Product Change Notification

(Notification – P2007039-FUT)

(MCP-AC-20-0006)

This notification announces the following assembly changes for selected RL78 devices in the HWQFN package. Please see the Appendix for additional details on all changes.

Appendix Q: Packing Specifications Change for 7mm×7mm 48pin HWQFN Tray

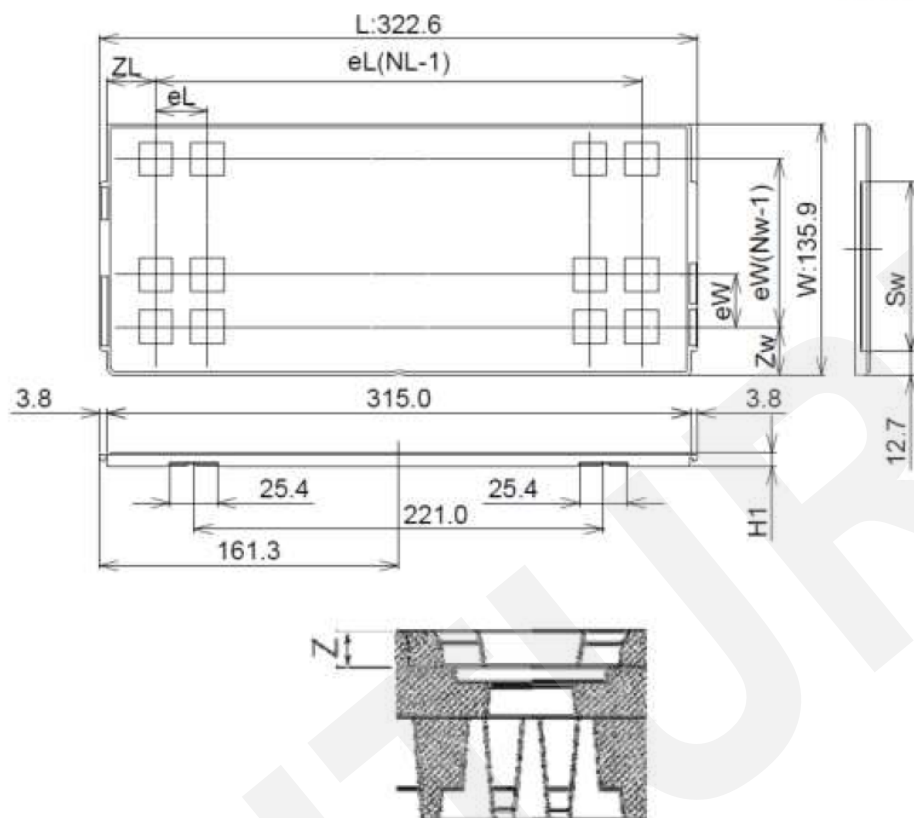
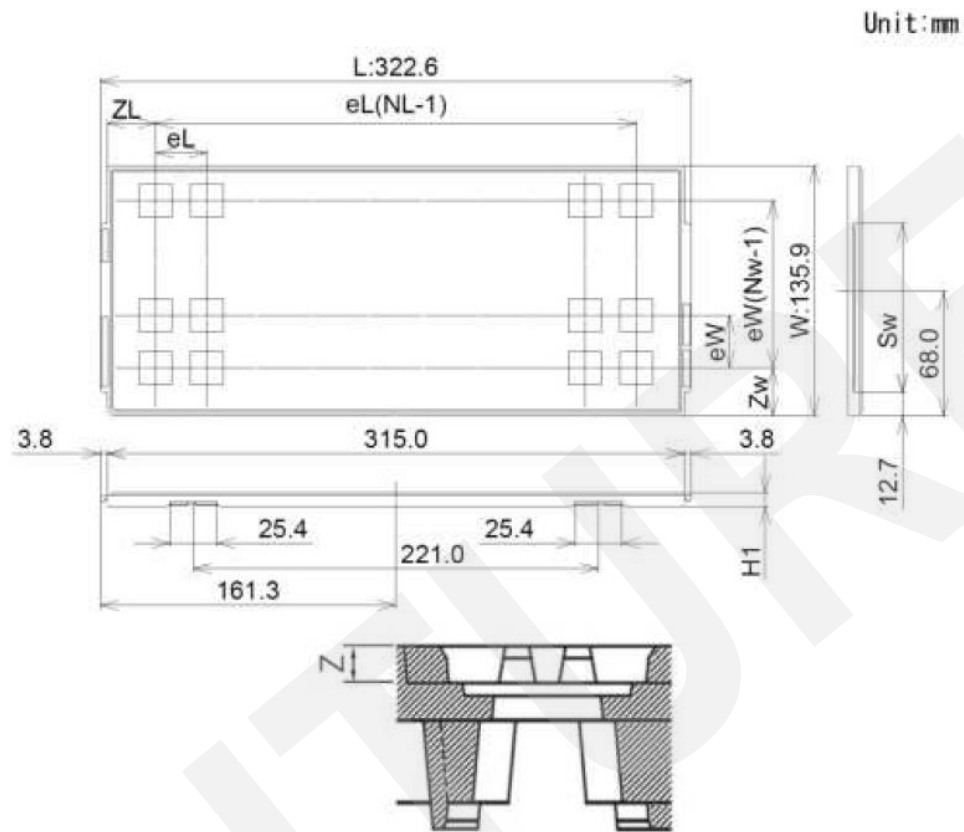
Tray Code		New	Current
		REV.C EAG0707-10	Rev.A EAM0707-10
Position dimension of cells	Z	1.40	1.55
	Zw	11.55	10.35
	ZL	11.80	10.00
	eW	9.40	12.80
	eL	9.40	11.80
	Sw	92.10	92.10
Thickness (mm)	H1	7.62	7.62
Number of cells	Nw	13	10
	NL	32	26
Maximum storage pcs IC/Tray		416	260
Maximum storage pcs IC/Inner box		3328	2080
Material		Carbon PPE	Carbon PPE
Heat resistant temperature		135°C MAX	135°C MAX
JEDEC/Custom		JEDEC	JEDEC
Surface resistance		Less than $1 \times 10^{11} \Omega/\square$	Less than $1 \times 10^{11} \Omega/\square$

Appendix U: Packing Specifications Change for 6mm×6mm 40pin HWQFN Embossed Tape (Tape & Reel)

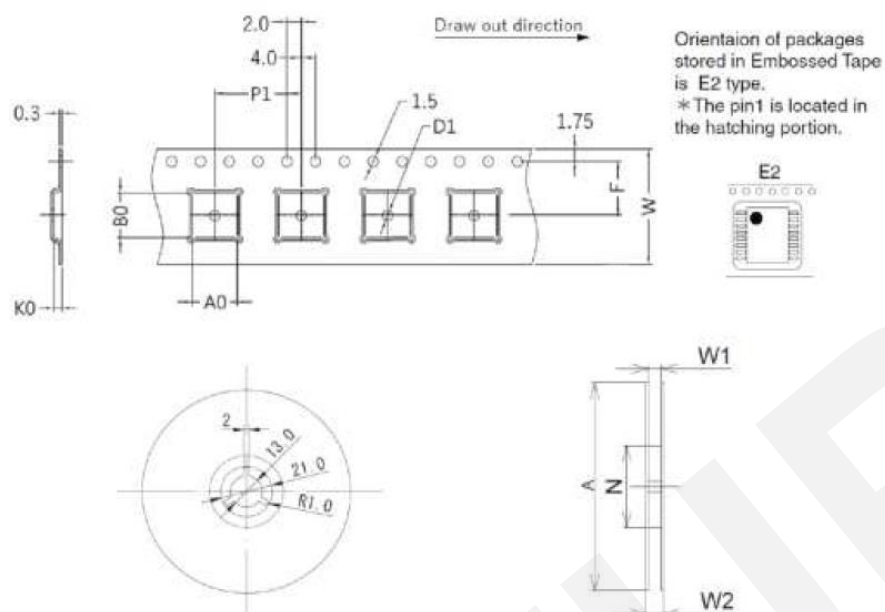
Tape Code		New	Current
		ATC-QFN0606-A410.PB	E16* 12-C3CA
Tape Dimensions (mm)	W	16.0	16.0
	P1	12.0	12.0
	A0	6.3	6.3
	B0	6.3	6.3
	K0	1.1	1.0
	F	7.5	7.5
	D1	1.5	1.5
Reel Dimensions (mm)	A	330	330
	N	96.5	100
	W1	16.8	17.5
	W2	22.2	21.5
Maximum storage Pcs. IC/ Reel		2500	2500
Material		Carbon PS	Carbon PS
Surface resistance		Less than $1 \times 10^{11} \Omega/\square$	Less than $1 \times 10^{11} \Omega/\square$

Appendix V: Packing Specifications Change for 7mm×7mm 48pin HWQFN Embossed Tape (Tape & Reel)

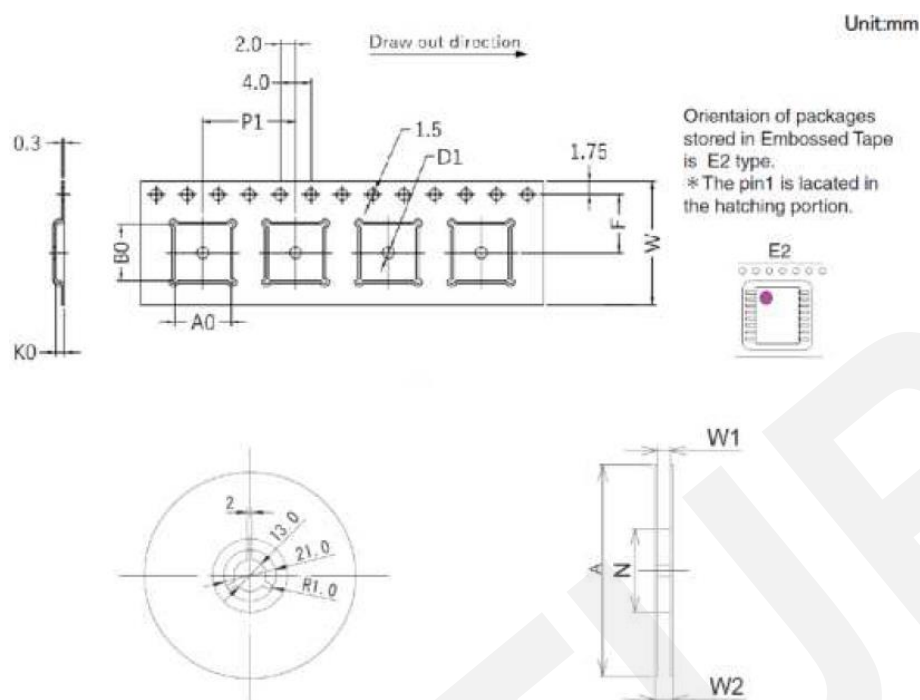
Tape Code		New	Current
		ACT-QFN0707-A410.PB	E16* 12-B9CA
Tape Dimensions (mm)	W	16.0	16.0
	P1	12.0	12.0
	A0	7.25	7.3
	B0	7.25	7.3
	K0	1.1	1.0
	F	7.5	7.5
	D1	1.5	1.55
Reel Dimensions (mm)	A	330	330
	N	96.5	100
	W1	16.8	17.5
	W2	22.2	21.5
Maximum storage Pcs. IC/ Reel		2500	2500
Material		Carbon PS	Carbon PS
Surface resistance		Less than $1 \times 10^{11} \Omega/\square$	Less than $1 \times 10^{11} \Omega/\square$

Desiccant is changed, but there is no change in the storage period. Shape or the like might be changed.
